MEETING AGENDA
The City of Beaufort
HISTORIC DISTRICT REVIEW BOARD
Wednesday, May 14, 2025, 2:00 P.M.
City Hall, Council Chambers, 2nd Floor – 1911 Boundary Street, Beaufort, SC

A. 1203 Bay Street (The Cuthbert House), PIN R120 004 000 771A 0000, awning replacement
Applicant: Chris Ramm, Owner

B. 1107 Prince Street, PIN R120 004 000 0503 0000, alterations, additions
Applicant: Benjie Morillo, Architect, Frederick + Frederick Architects

CITY OF BEAUFORT
HTRC – Pre-Design Application Meeting
1911 BOUNDARY STREET
BEAUFORT, SOUTH CAROLINA 29902
(843) 525-7011 FAX: (843) 986-5606

Current Green Canvas Awning

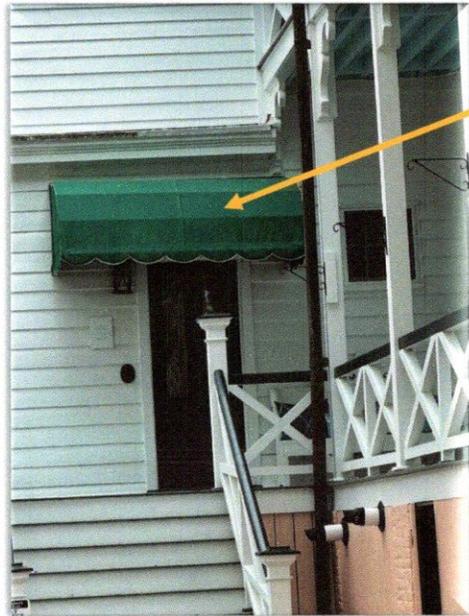
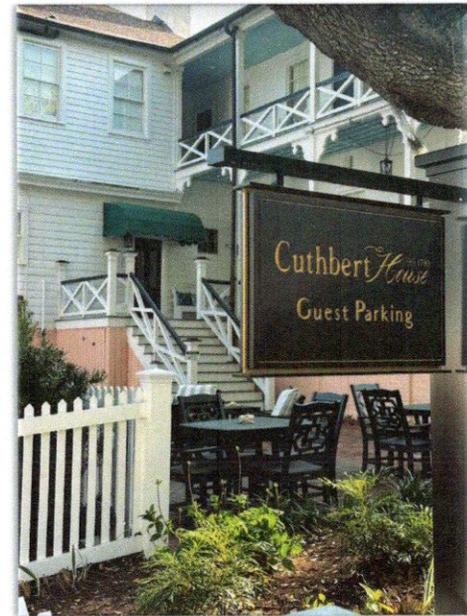
- **Planning and Zoning:**
 - Provide full dimensions of existing awning so we can have a direct numbers comparison between the old and new.
 - Lettering on the awning turns it into signage. Will need to fill out a sign application form.

- Staff recommend that the replacement awning be made of canvas on a metal frame.

- It is recommended that the awning be a shed type with a triangular section. This shape is most appropriate to tuck in under the existing architectural soffit and molding detail above the door and below the second floor.
- It is recommended that the applicant consider a retractable version of the awning so that it can be stored on nice days and not obstruct the architectural details of the building.
- **HBF:**
 - In agreement with Architectural comments.
 - 1. Historic look requires fitting with the timeframe of the building
 - 2. Awning is almost oriental in style – not appropriate for the structure/district.
 - Canvas awning is more appropriate.
 - Awning is supposed to frame, not go beyond the opening/door/window.
 - For longevity, consider a flat metal shed awning without the crimps. Would be more appropriate for the structure.

Option 1 - will be pursued for HRB approval

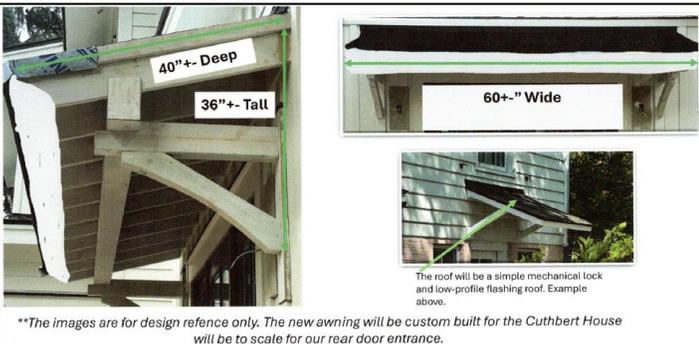
- **Planning and Zoning:**
 - Contributing Structure (c. 1790)
 - T4-HN
 - Will require HRB review/approval, NOT Staff level
- **Architecture:**
 - While staff still support a canvas awning, staff is supportive of option 1 with the following comments:
 - Roof should mimic the existing standing seam roof shown on the left with its simple mechanical lock and low profile flashings.
 - The elimination of exposed rafter tails is a positive
 - Awning shall be sized to frame the existing door.
 - Applicant to provide a simple sketch with dimensions.
 - Staff level approval once all items submitted.
- **HBF:** In agreement with Architecture

<u>Item</u>	<u>Applicant response(s) / meeting summaries</u>
New awning must be able to withstand winds of 140+ mph	Applicant has acknowledged this requirement.
Replacement with new canvas awning - staff supported	Not an option for the applicant (for longevity reasons)
Replacement with metal awning - not supported by staff & HBF	Applicant has agreed to dismiss this alternative
Replacement with shed-roof like awning (custom built) - staff-recommends this alternative without the rafter tails	<p>a) Applicant is favorable to this alternative, as it also matches similar shed-roof on neighbor's property (1207 Bay St.)</p> <p>b) Applicant has submitted new option without rafter tails (Option #1 to be further pursued for approval)</p>
New shed-roof awning to complement door frame width (60") and respect soffit & molding above rear door & to resemble primary architectural details of The Cuthbert House	The proposed shed-roof awning (60" x 40" x 36") will have a standing seam metal roof that mimics the existing roof on the lower-level (east side) & entrance of 1207 Bay St. (neighbor to west); also, the roof will have a simple mechanical lock and low-profile flashing. The awning will be sized to frame the existing door.

- A. Applicant to provide architectural drawings including a roof plan, section, and details showing the wall flashing, fascia, and brackets.
- B. Applicant to submit a cutsheet for the metal roof, as well as the roof brackets if they are to be premanufactured. The roof cutsheet should indicate the proposed color and seam profile.
- C. Applicant to confirm if paint colors are to match that of the existing house.

④ WEST ELEVATION
 1/4" = 1'-0"

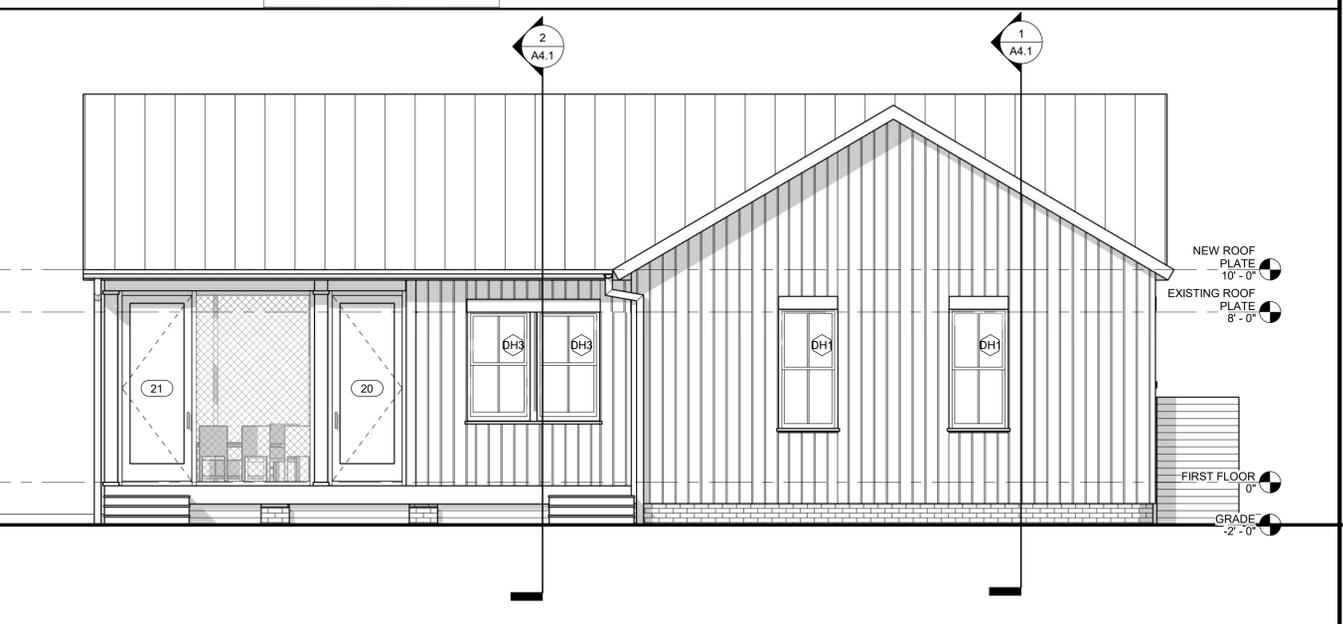
1. Applicant to note that all windows and doors must have external grilles with internal spacer bars.
2. Staff recommends the applicant add one or two windows on the west façade at Bedroom 1 to break up the continuous stretch of blank wall. Staff would be supportive of either of the window sizes already shown on the west façade.
